Title		
Size	Number	Revision
A4		
Date:	8-18-2025	Sheet of
File:	C:\Users\...\Top Level.SchDoc	Drawn By:

Title		
Size	Number	Revision
A4		
Date:	8-18-2025	Sheet of
File:	C:\Users\...\Radio.SchDoc	Drawn By:

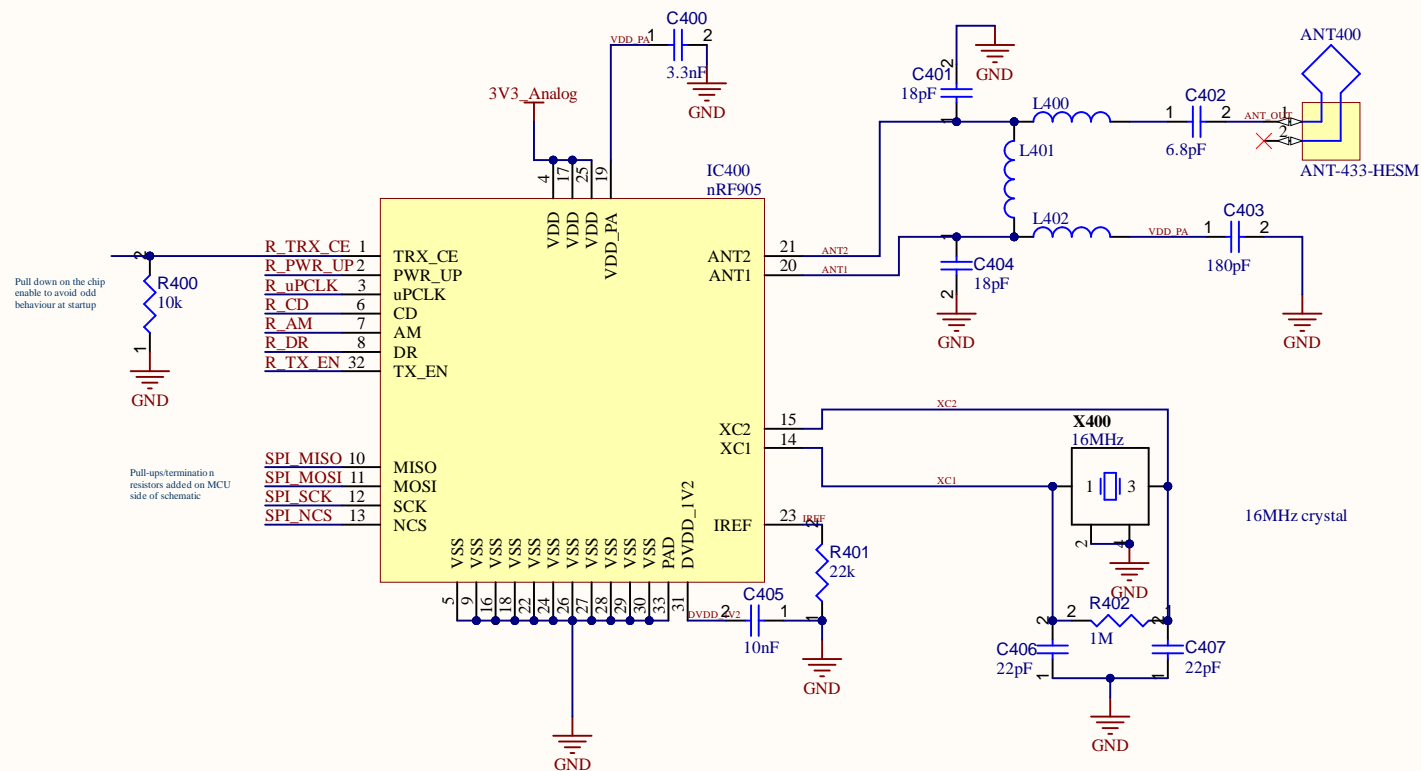
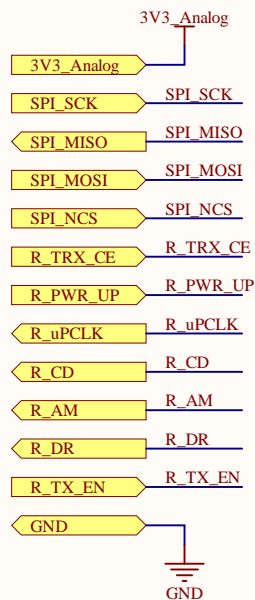
Add supply decoupling, ensure doesn't exceed LDO capacitance
